ENGR	FEB	DATE	ISSUE	1
DRAWN	FEB	DATE	ISSUE	1
	2-2-66		ISSUE	1
	ADDED: 62A3A & 66C4B IN TITLE.			
	FEB	DATE	ISSUE	2
	2-15-67		ISSUE	2
	ADDED 35K3A IN TITLE & NOTE			
	2-13-68		ISSUE	3
	ADDED 35R3A + 35S3A IN NOTE			
	WKM			
	10-23-68		ISSUE	4
	ADDED: 35U3A TO TITLE AND NOTE			
	REMOVED: 62A3A FROM TITLE & NOTE			
	8-7-70		ISSUE	5
	11-5-70			
	11-5-70			
USED ON	DWG	35K3A, R3A, S3A, U3A, AC3A, AE3A, AL3A, 66C4B, C3A, H3C & K3A DIALS COMMON SWITCH & 35BC3A		
		WESTERN ELECTRIC COMPANY, INC. ENGINEER OF MANUFACTURE		
		BELL TELEPHONE LABORATORIES MURKIN		
		B-659982		
		NO. OF SHEETS PER SET SEE SHEET 1

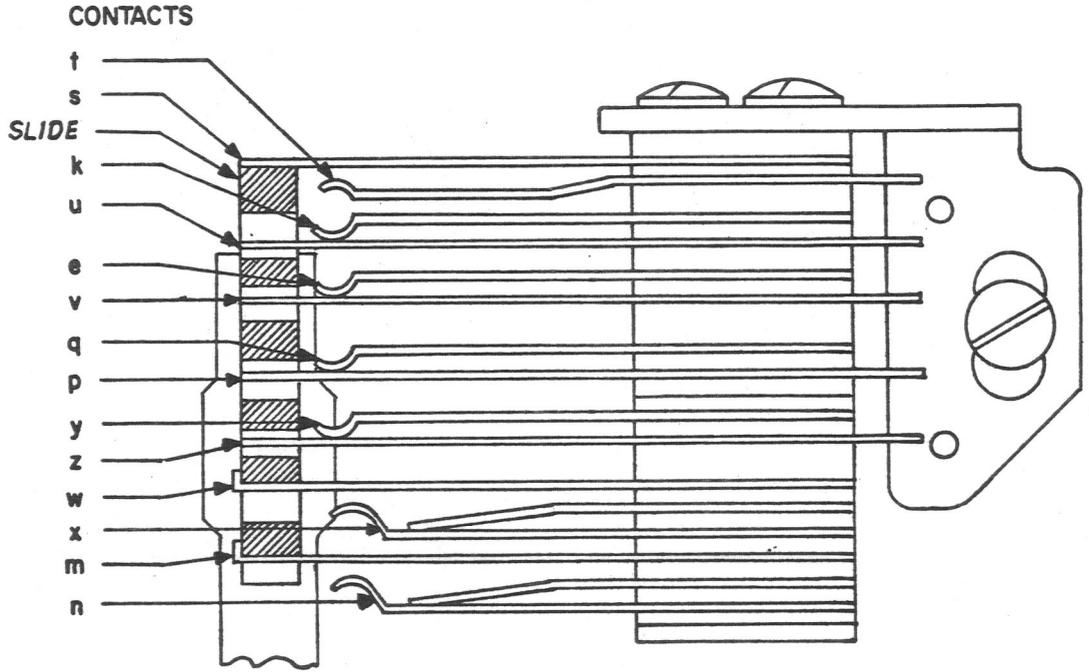
10 1/4	ISSUE NOTES CONT
8-7-70	ISSUE 5
	ADDED: 35AC3A DIAL
6-11-71	6
	ADDED: 66H3C TO TITLE 35AE3A TO TITLE AND NOTE.
7-13-72	7
	ADDED: 35S3D TO TITLE AND NOTE
3-8-73	8
	ADDED: "35AL3A" TO TITLE & NOTE. "66K3A" TO TITLE. REMOVED: "35S3D" FROM NOTE & TITLE. <i>EH</i>
6-17-74	9
	ADDED: 35BC3A TO TITLE & NOTE
9-7-79	10

NOTE:
FOR 35K3A, R3A, S3A, U3A, AC3A, AE3A AL3A AND BC3A
DIALS - PQ CONTACTS REVERSED.
